11 September 2019

**Subject: Site Audit of 297 King Street, Mascot, NSW (LBJ 19/02)
Interim Audit Advice #4 Regarding Revised Project Boundary
Geosyntec Project: GSY0099**

1 SITE - DEMOLITION
1:500

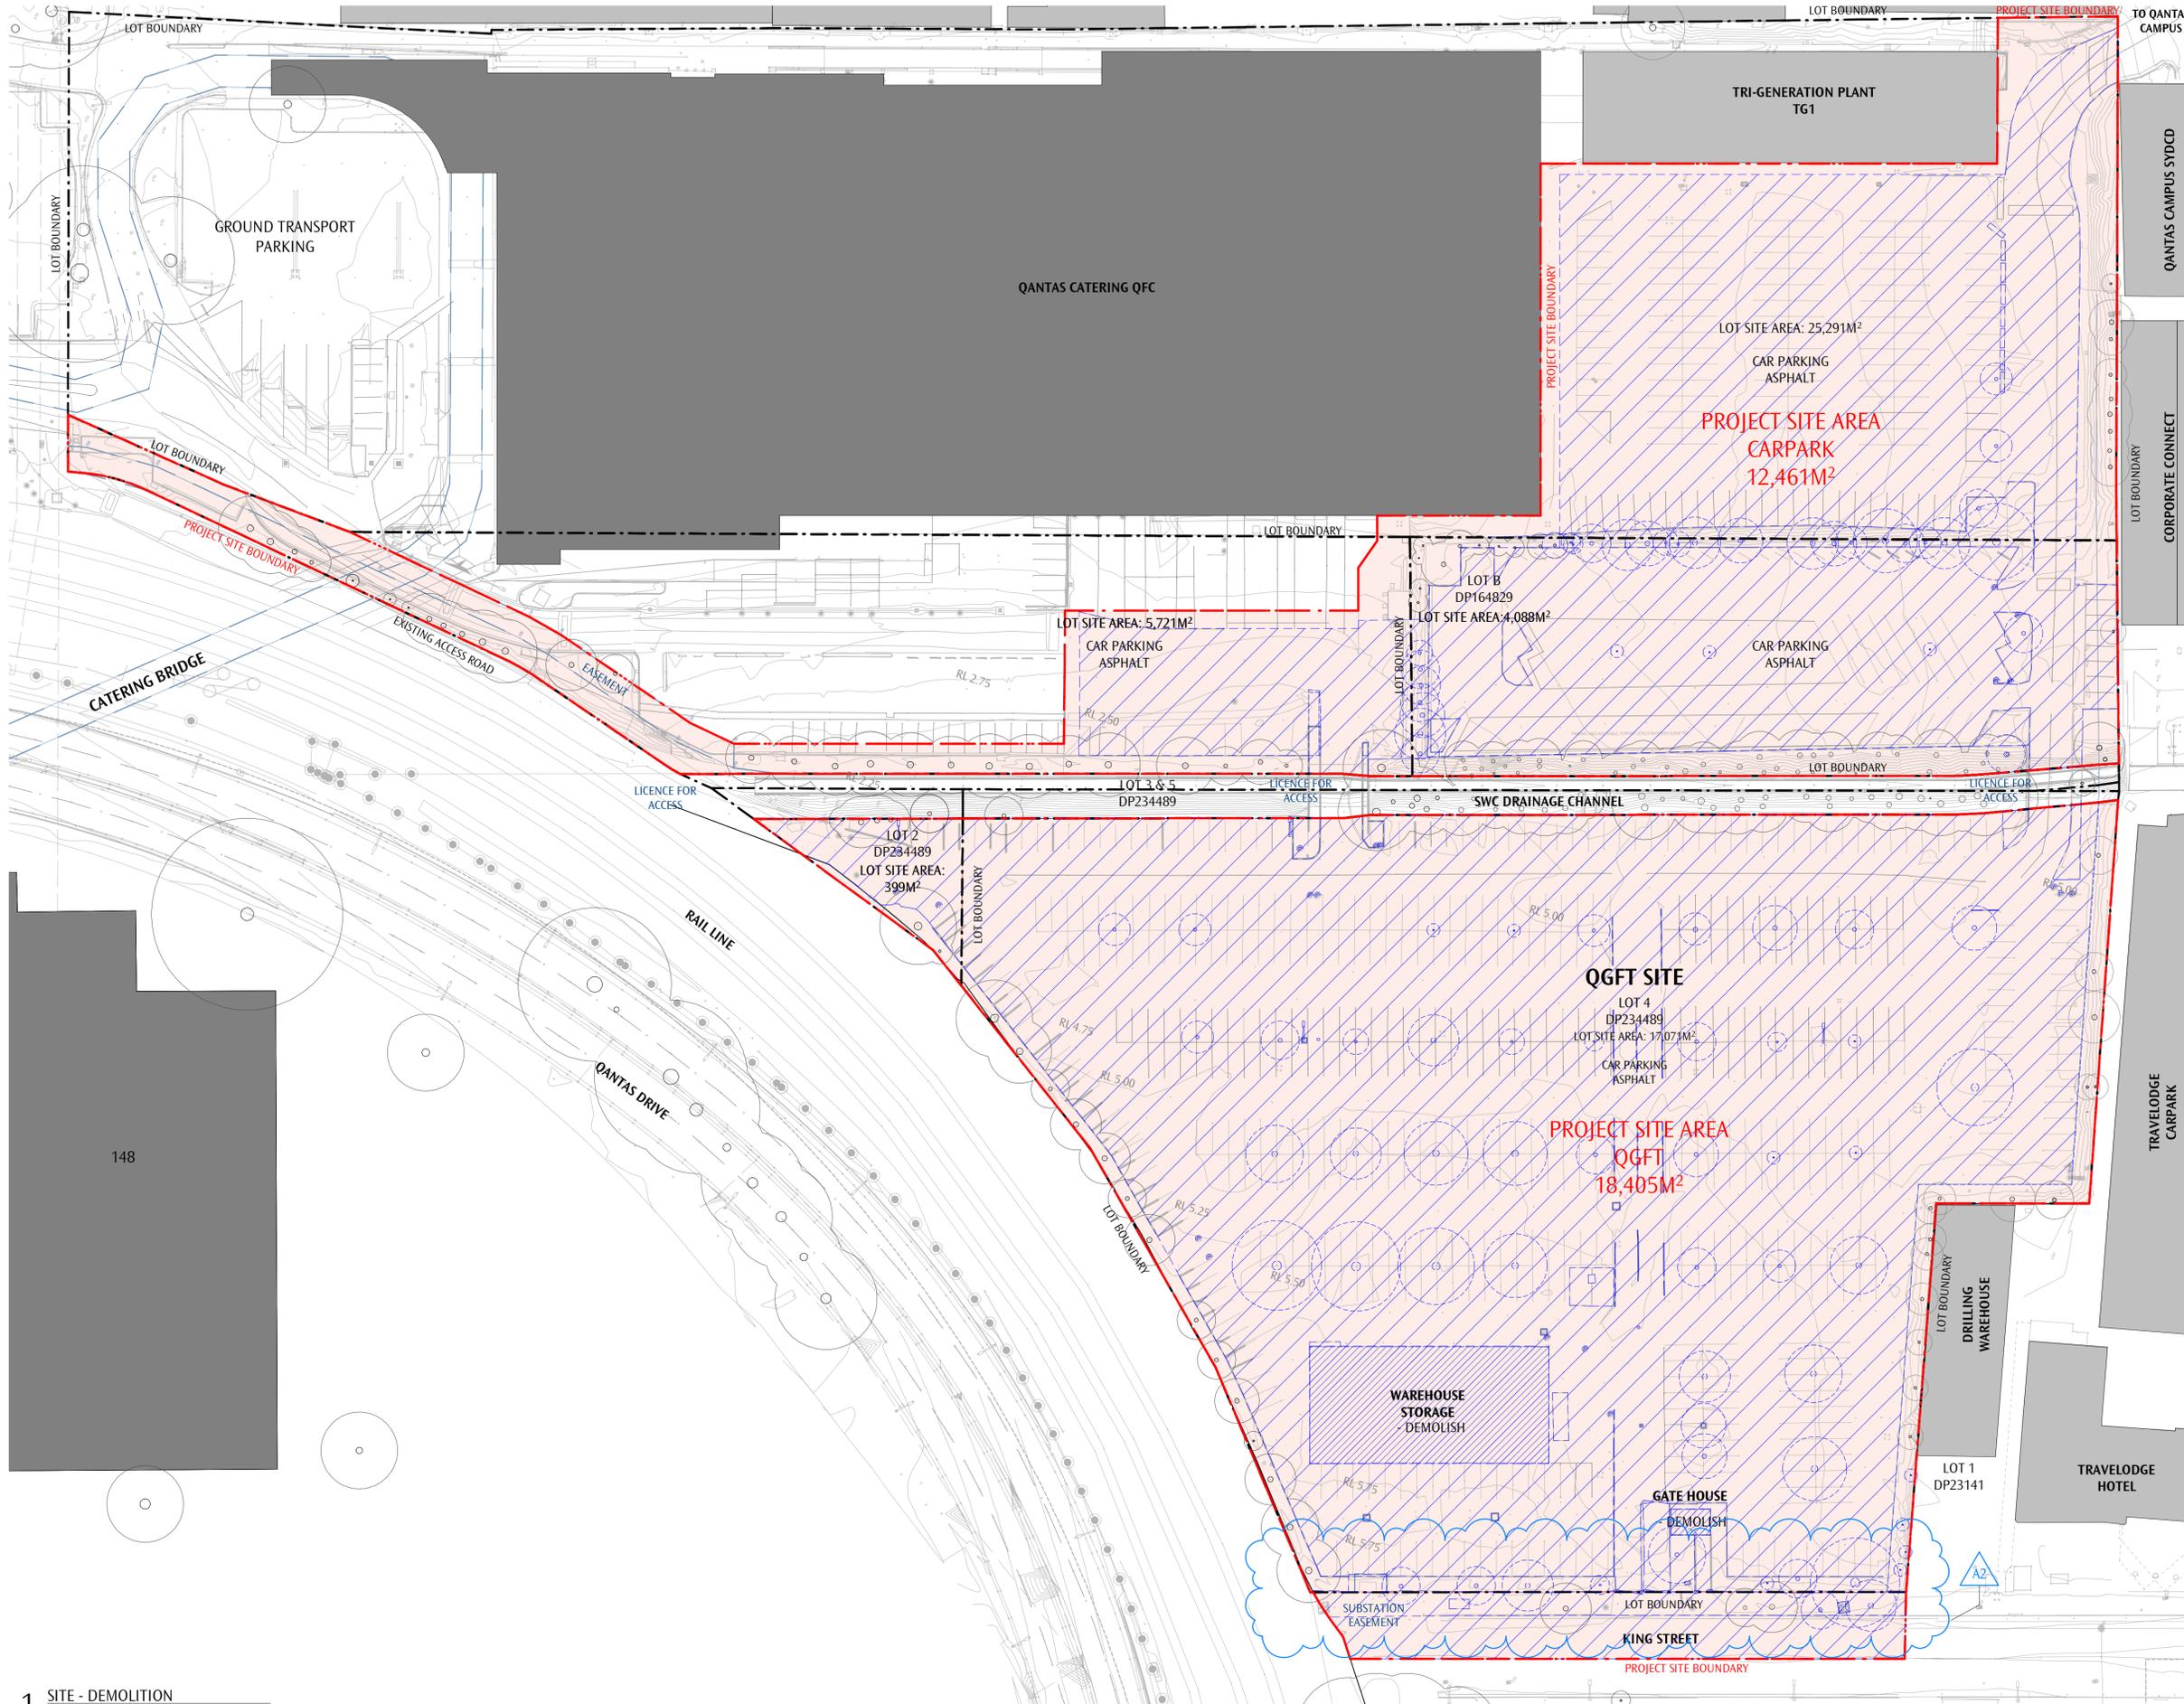
The Auditor has reviewed the revised project boundary in terms of appropriateness for making a land use suitability determination for the proposed redevelopment, from a contamination perspective. The following observations were made:

- The revised project boundary appears to address all areas of redevelopment activity for the site;
- The revised boundary was overlaid on the site investigation location figures from the Arcadis (2019) environmental site assessment report, and there is sufficient spatial

coverage of soil and groundwater investigation data for the audit area to form the basis of a land use suitability determination;

- There is sufficient information on the status of potential off-site contamination sources to assess their impact (or lack thereof) on the revised project area.

Accordingly, the Auditor considers that the revised project boundary is suitable and appropriate as an audit boundary for the site audit, and the revision to the boundary does not impact on the ability to make a land use suitability determination for the project area, from a contamination perspective. In keeping with previous interim advice, the land use suitability determination will be made at the completion of bulk earthworks, having regard to the movement and/or removal of any fill material, importation of any fill material from external sources, the final surface completion across the audit area and completion of a long-term environmental management plan for the site identifying the appropriate management of any residual contamination risks at the site.
